Project CINEWORLD BARNSELEY

Drawing PROPOSED EXTERNAL SIGNAGE

Drawing No. 1722|BA-019 Revision H

ELEVATION A

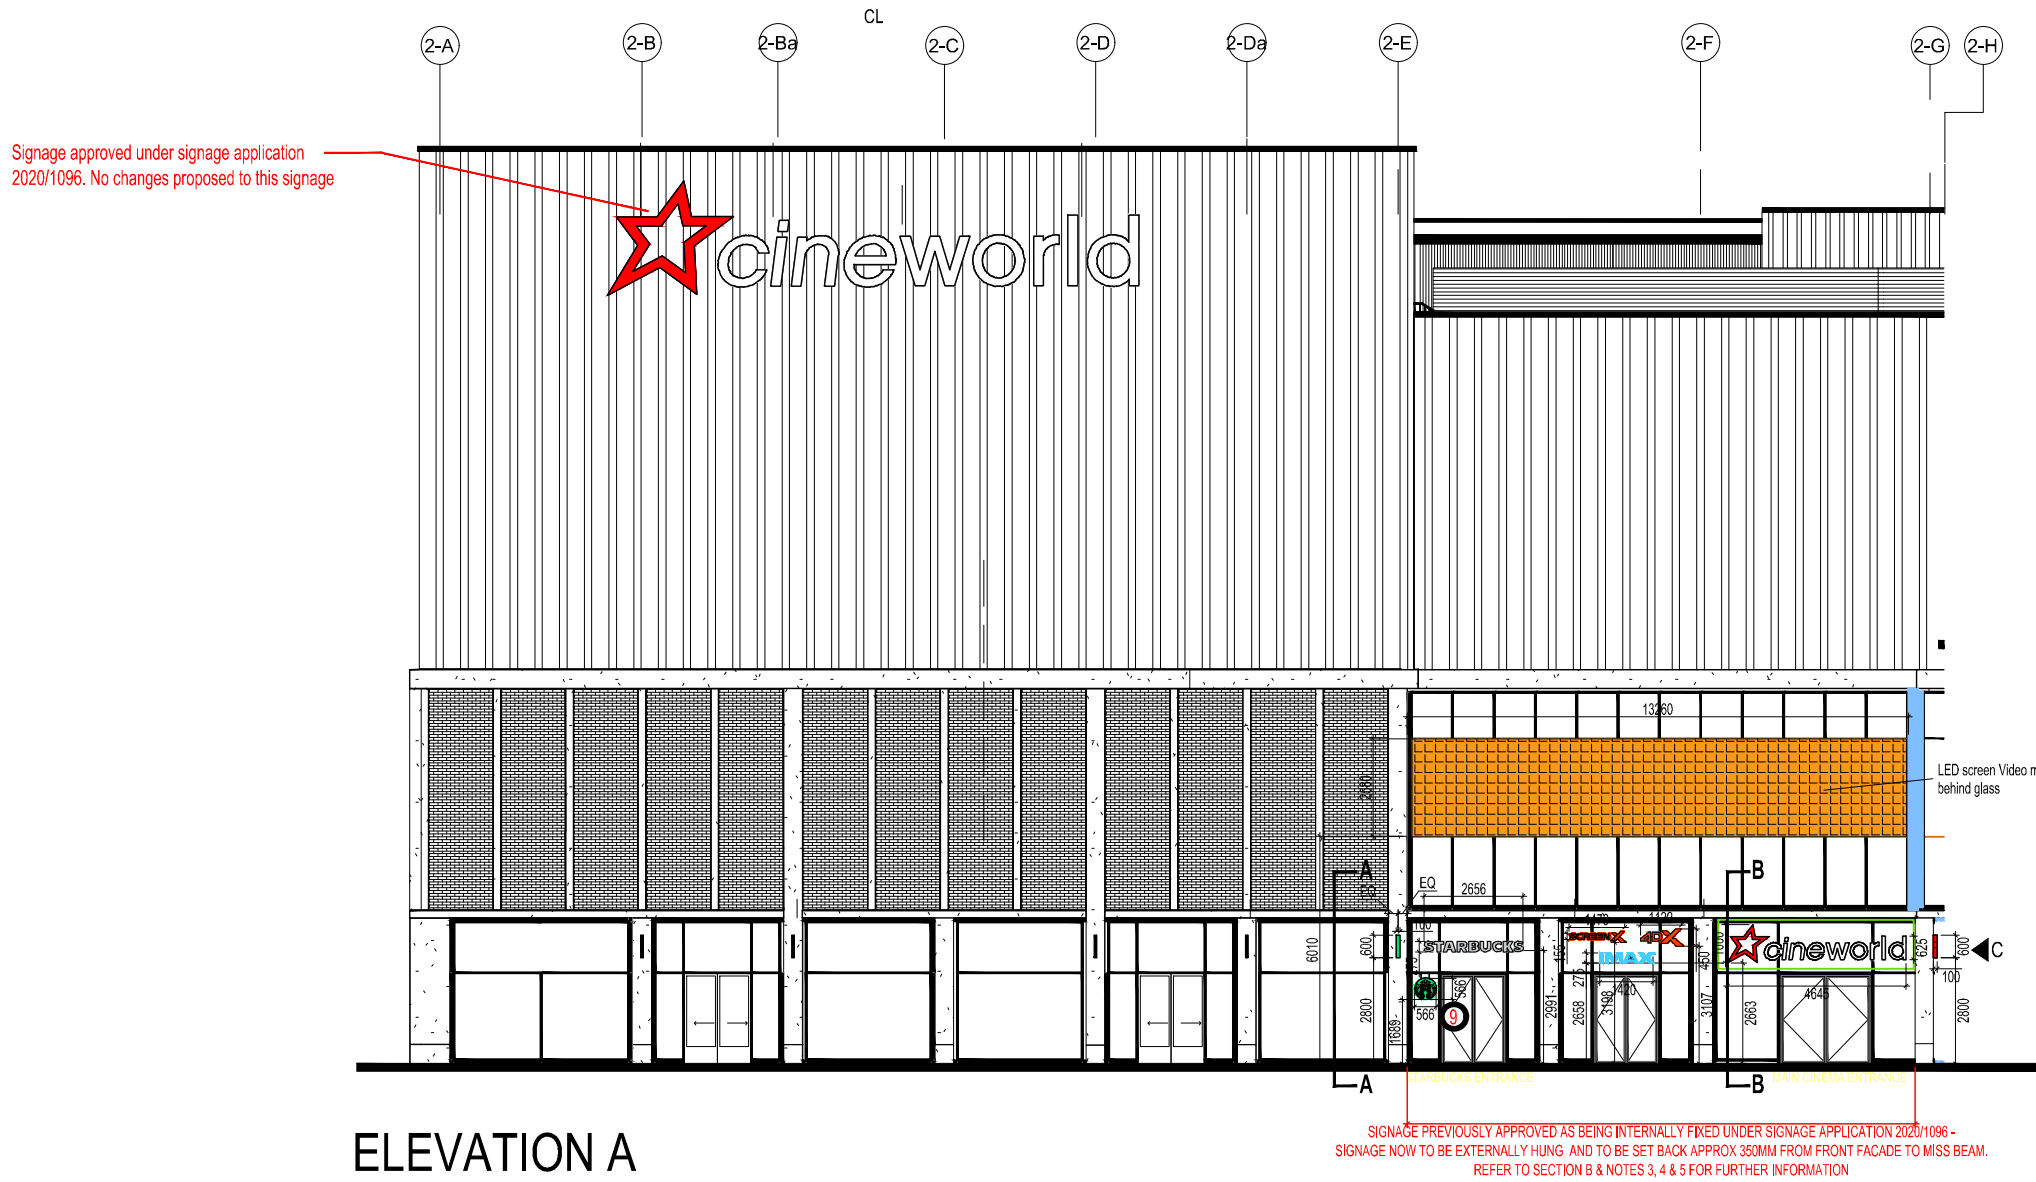
- PROPOSED AMENDMENTS FROM PREVIOUS APPROVED SIGNAGE APPLICATION**
- Proposed signage order altered - approved signage order SCREEN X, 4DX, IMAX. Proposed order IMAX, SCREEN X, 4DX

- Proposed signage order altered - approved signage order SCREEN X, 4DX, IMAX, STARBUCKS. Proposed order IMAX, SCREEN X, 4DX, STARBUCKS.
 - Cineworld signage previously approved as internally hung behind glazing. New proposal is for the the signage to be externally hung 350mm set back from the front facade to miss steel beam. Please refer to Section B for further information.

ELEVATION B

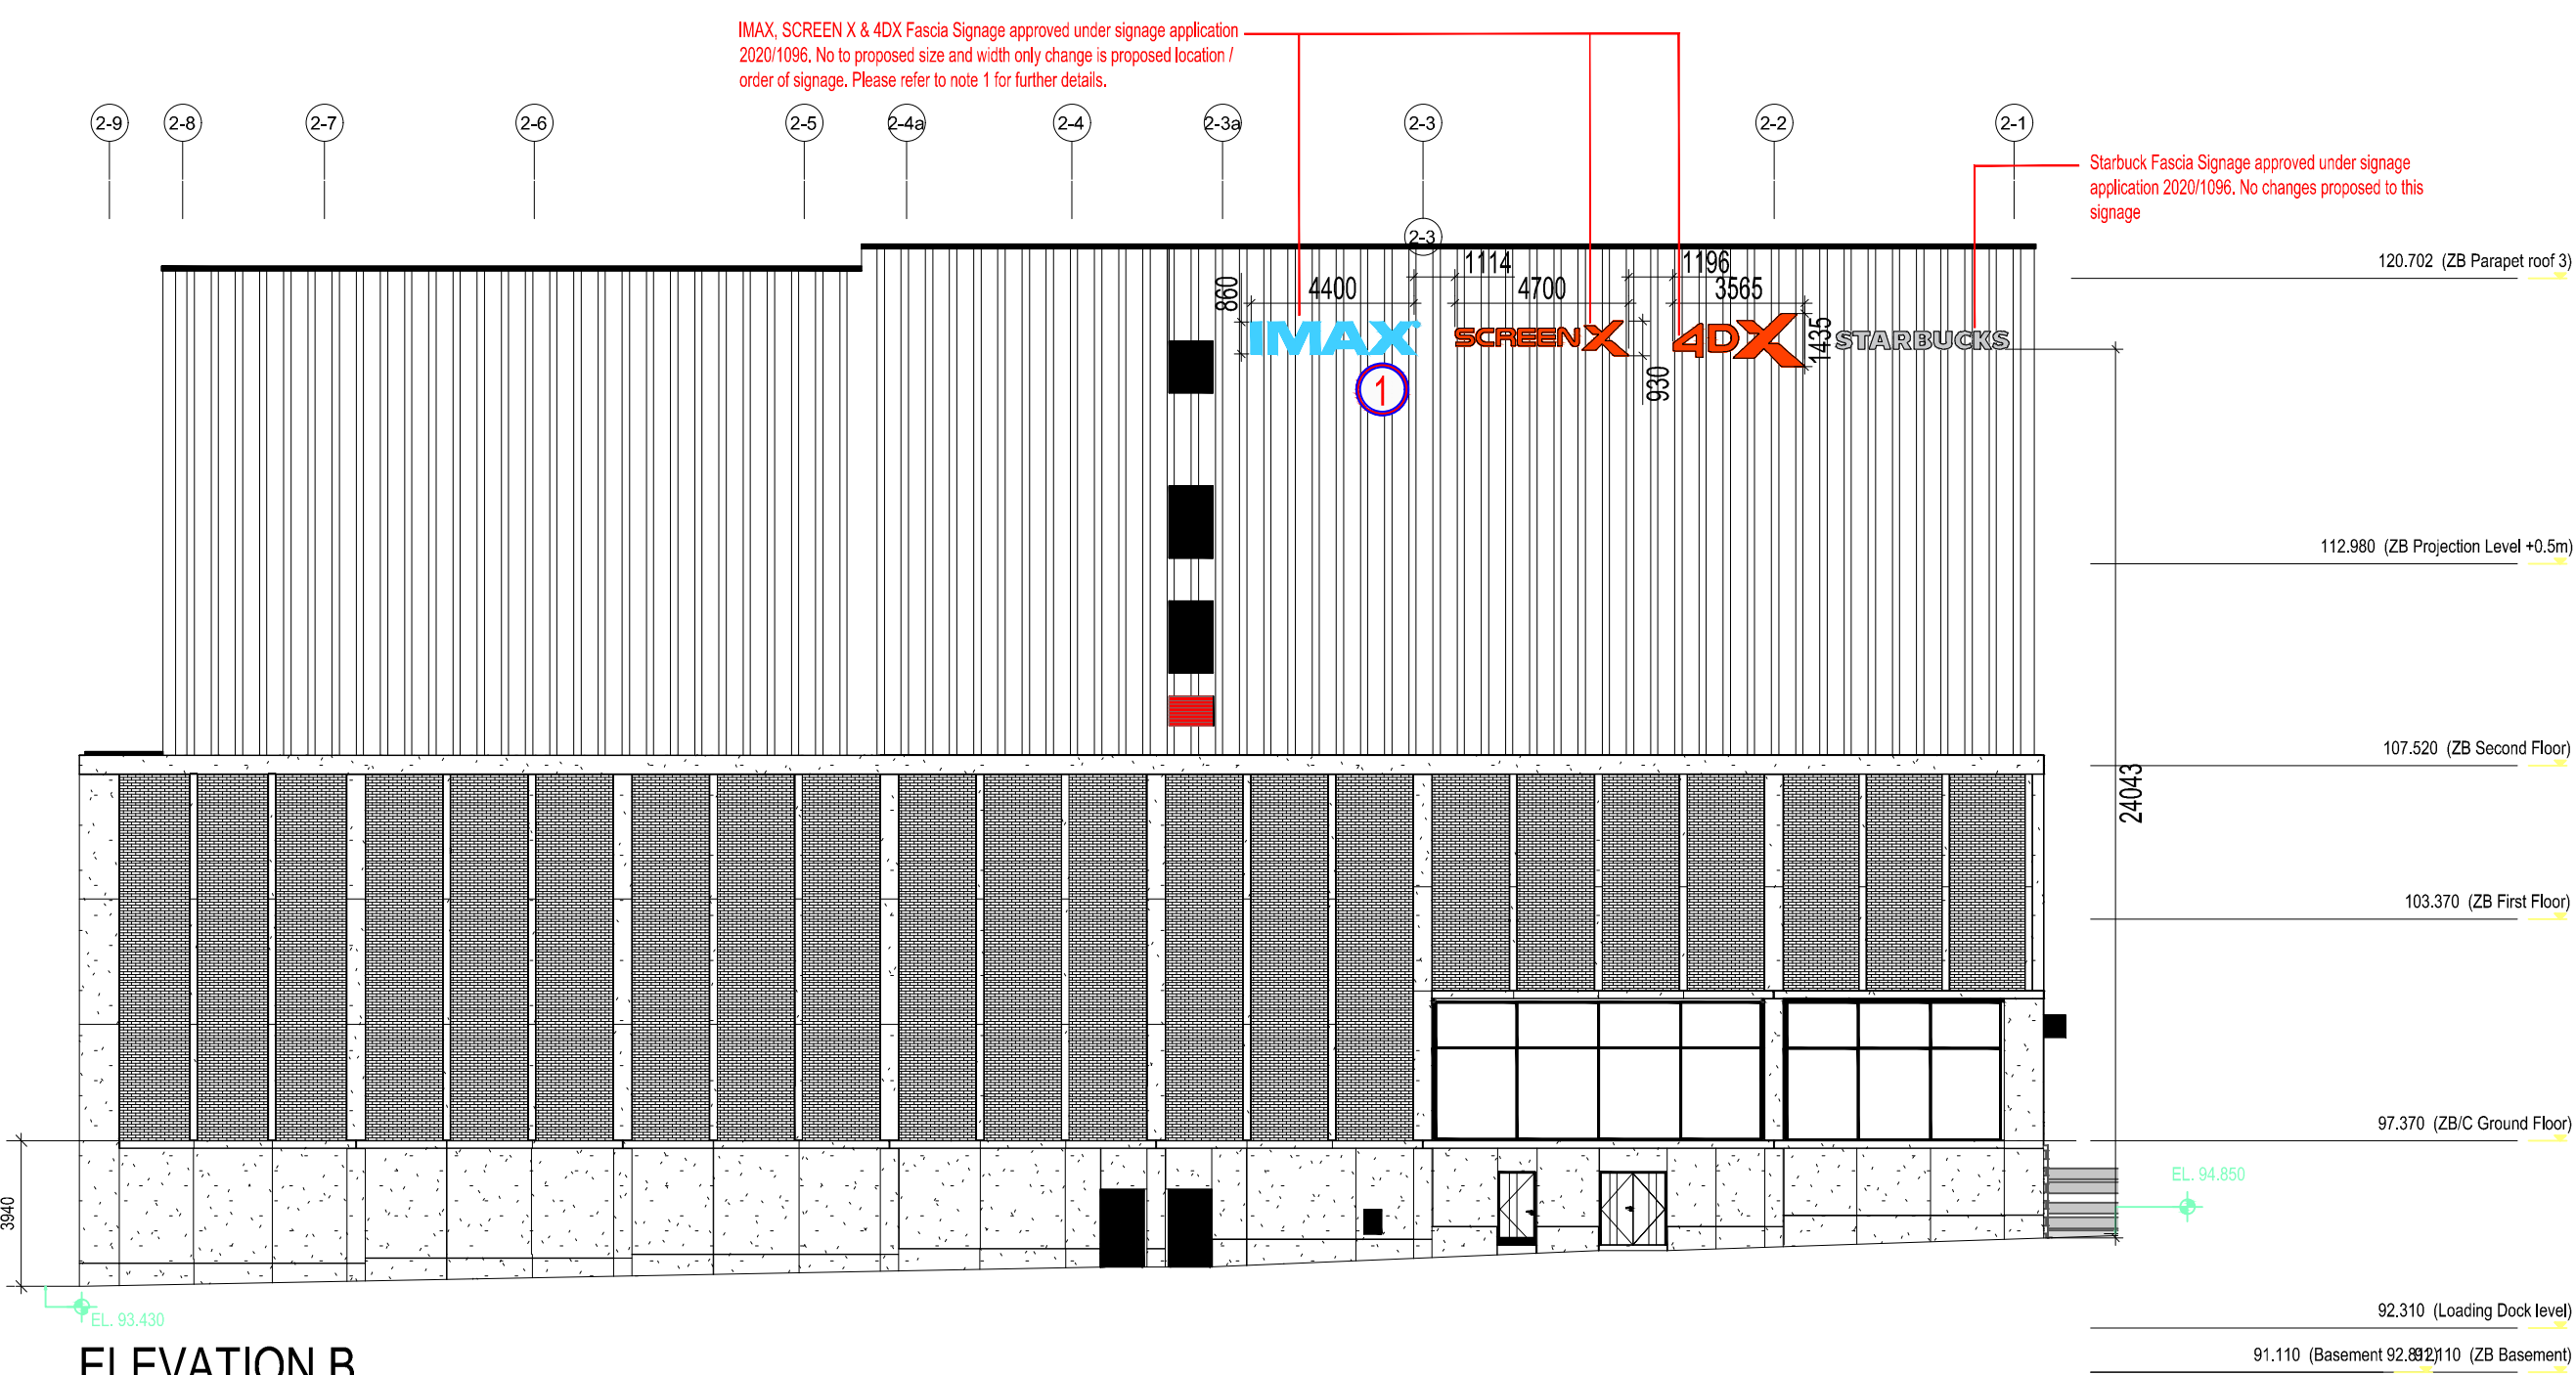
- SCREEN X, 4DX & IMAX signage previously approved as internally hung behind glazing. New proposal is for the the signage to be externally hung 350mm set back from the front facade to miss steel beam. Signage to be hung as per detail in Section B.

- STARBUCKS signage previously approved as internally hung behind glazing. New proposal is for the the signage to be externally hung 350mm set back from the front facade to miss steel beam. Signage to be hung as per detail in Section B.

- New Starbuck's illuminated projecting signage to be installed on column.
 - New illuminated Cineworld Star to be mounted on external column.
 - New Led Screen videos Mesh to be internally installed behind the glazing to the first floor.

SECTION B

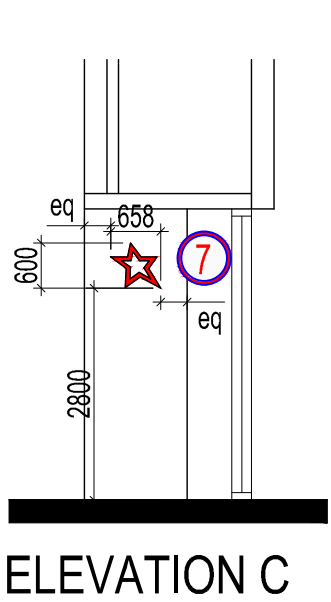
SIGNAGE PREVIOUSLY APPROVED AS BEING INTERNALLY FIXED UNDER SIGNAGE APPLICATION 2020/1096 - SIGNAGE NOW TO BE EXTERNALLY HUNG AND TO BE SET BACK APPROX. 350MM FROM FRONT FACADE TO MISS BEAM. REFER TO SECTION B & NOTES 3, 4 & 5 FOR FURTHER INFORMATION
